**Clarification Note # 2**

**Invitation to Bid (ITB) No. UKR/01/2020 - Supply and Delivery of Stand-Ready Vehicle, Laboratory Control and Technical Equipment for Mobile Chemical Identification Laboratory and Provision of Associated Services on Training**

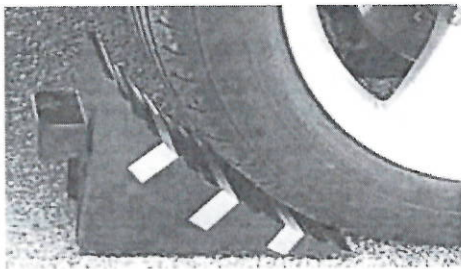
**Question 4:** LOT I, Point 4.4 Car wheel chock: Please provide more detailed requirements for additional equipment for the vehicle, for mounting the car wheel.

**Answer 4:** Wheel chocks (wedges of sturdy material) are to be used for additional vehicle's safety. They are placed closely against a vehicle's wheels, front pair or rear depending on the situation, to prevent accidental movement and assist brakes in holding the vehicle still. They are, of course, to be compatible with the wheels' size of the proposed vehicle. Please kindly find the picture below for illustrative purpose:
